# M5 Junction 10 Improvements Scheme

Road Safety Audit 1 Response Report

#### Road Safety Audit 1 Response Report

<b>Report Title:</b>	M5 Junction 10 Stage 1 RSA Response Report
<b>Date:</b>	13/09/23
<b>Document reference and revision:</b>	GCCM5J10-ATK-GEN-ZZ-PC-CH-000014 C04
<b>Prepared by:</b>	Atkins
<b>On behalf of:</b>	Gloucestershire County Council

Figure 4-1 - Swept Paths of Private Car

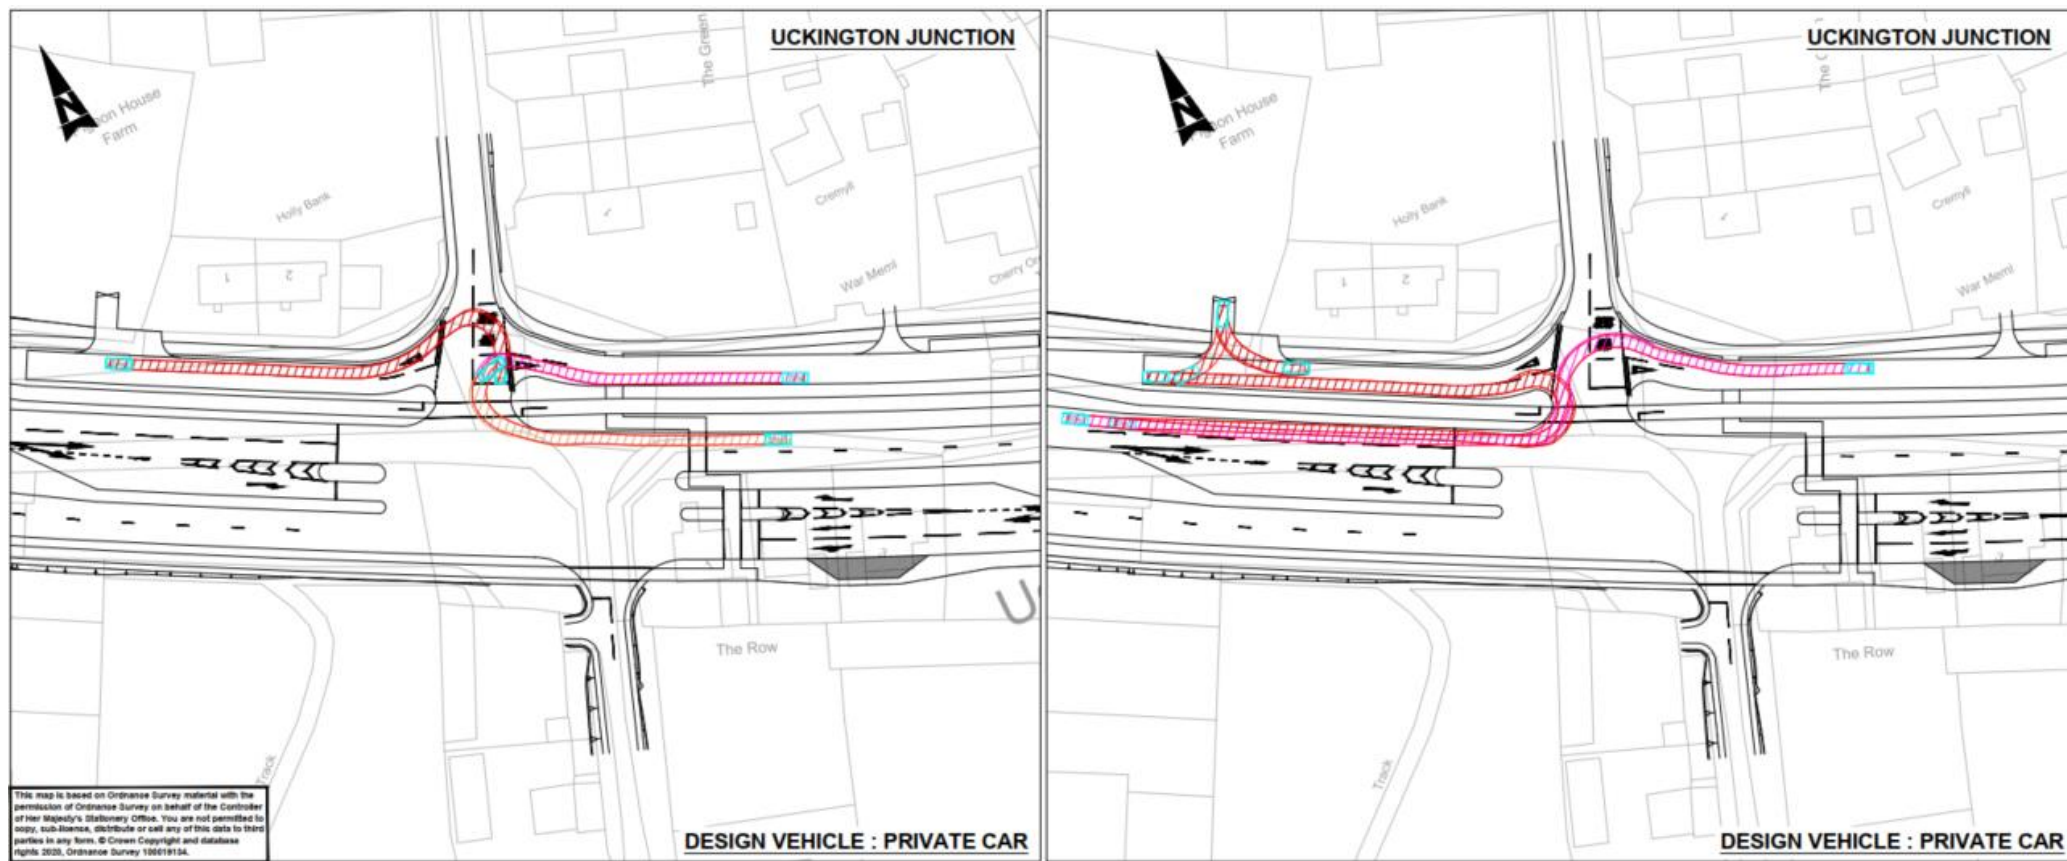
RSA Problem	RSA Recommendation	Design organisation response	Overseeing Organisation response	Agreed RSA action
<p><b>PROBLEM 7</b></p> <p><b>Location:</b> Close proximity of signal stop lines on The Green to the service road located either side of the junction</p> <p><b>Summary:</b> The audit team noted that The Green has service road located very close to the stop line with the A4019. The close proximity of the stop line and access to the service roads may make it difficult for users of the side roads to see the signal heads and if it is safe to proceed. Vehicle exiting the Western service road may not be picked up by the sensors of the signals and this could lead to the pulling out across the junction into the path of a vehicle entering The Green which could result in a slight injury accident.</p> <p>(Note: This problem relates only to GCC's local roads, not to National Highways' network)</p>	<p>The audit team recommend that the signal heads at the stop line on the Green should be easily visible from either of the side roads. Sensors may also be required on the Western service road to help ensure it does not pull out when the traffic light are on red as they may not be able to complete the manoeuvre and could block vehicles entering The Green.</p>	<p>The design organisation accepts the problem but suggests an alternative solution:</p> <p>An additional primary signal will be provided. These signals will be positioned for visibility to traffic on the main side road carriageway (The Green) but should be visible to access road traffic without causing confusion as to where the right of way applies.</p> <p>'Keep Clear' markings will also be added to prevent vehicles blocking the entry width into the access to the eastern service road. The available space between the stop line and the start of the 'Keep Clear' marking would be approximately 5m and sufficient for a standard car to enter. Access to the service road could be temporarily obstructed if a large vehicle pulled up to the stop line either from The Green or from the western service road and if this corresponded with a time when other vehicles were trying to gain access to The Green/eastern service road from the A4019. However, this has been considered to be low</p>	<p>Happy with the response provided by the designer and have no further issues to raise at this time.</p>	<p>Preliminary Design updated to include amendments detailed in design organisation response.</p>

RSA Problem	RSA Recommendation	Design organisation response	Overseeing Organisation response	Agreed RSA action
		<p>frequency given the relatively low flows on The Green and even lower flows on the service roads.</p> <p>The installation of a traffic signals ahead warning sign to TSRGD Diagram 543 with an arrow subplate on the service roads could also be considered at detailed design.</p> <p>The design at this location comprises a non-typical layout based on the need to minimise impacts on existing properties on the north side of the A4019 and Manor Farm land and outbuildings to the south of the scheme. Further geometrical improvements are constrained without acquiring additional land.</p> <p>Swept path analysis has been undertaken and examples of these are included in Figure 4-1 to Figure 4-4. Large vehicles including a 7.5t box van and refuge vehicle have been assessed and these can perform the likely turning movements with some limited over-run into opposing lanes in places.</p>

Figure 4-5 - West Cheltenham Link Road Long Section

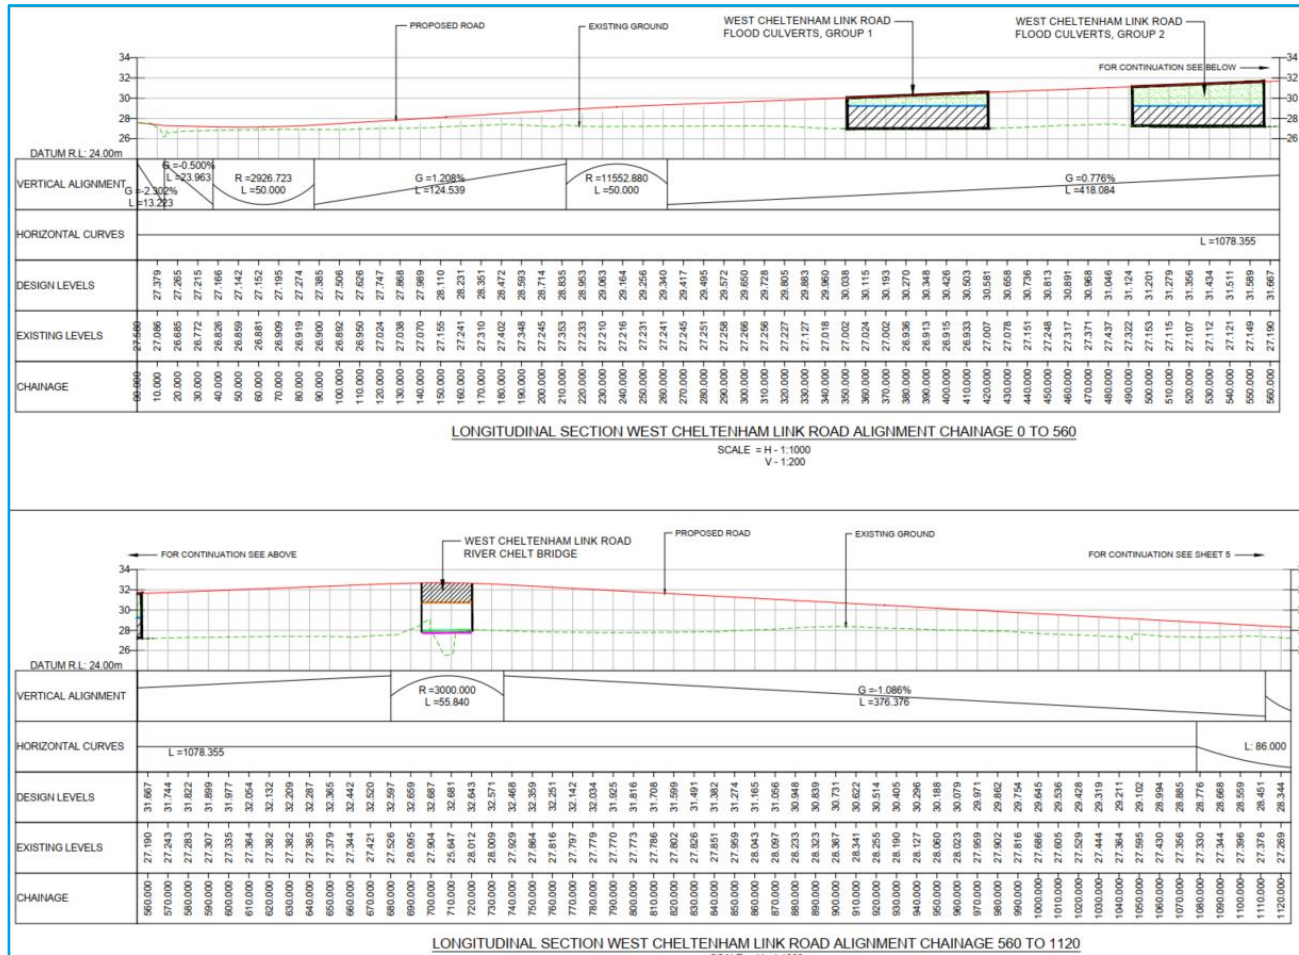
RSA Problem	RSA Recommendation	Design organisation response	Overseeing Organisation response	Agreed RSA action
<p><b>PROBLEM 12</b></p> <p><b>Location:</b> West Cheltenham Link Road</p> <p><b>Summary:</b> The audit team discussed the new link road and commented on how rural and straight the road was and that this could create problems with vehicles driving at inappropriate speeds. If speeding does occur on the straight rural link road, the severity of the collision is likely to increase from slight to serious.</p> <p>(Note: This problem relates only to GCC's local roads, not to National Highways' network)</p>	<p>The audit team were unaware of what the speed limit is proposed to be on the new link road that links the B4634 and the <b>A4019</b>, but there does not appear to be any measures to ensure that vehicle speeds are kept to an acceptable level. The audit team would be interested to know what the proposed speed limit for the new road is and what measures are being undertaken to try and ensure the majority of road users comply with the speed limit.</p>	<p>The design organisation accepts the problem and recommendation made by the RSA team.</p> <p>The proposed speed limit along the West Cheltenham Link Road is 50mph and the road has been designed to an 85kph (50mph) design speed. Measures to assist speed control will include the vertical alignment crest curve at River Chelt Bridge. This has been reduced to one step below desirable minimum for the 85kph design speed, in accordance with CD 109 for single carriageway design to restrict forward visibility and introduce a clear non-overtaking section. The long section is included in Figure 4-5.</p> <p>We will also include proposed woodland planting on earthwork slopes to back of verge position. These will reduce the apparent openness of the road. Consideration will be given to additional repeater signs and road marking roundels at detailed design stage.</p>	<p>Happy with the response provided by the designer and have no further issues to raise at this time.</p>	<p>Preliminary Design updated to include amendments detailed in design organisation response.</p>
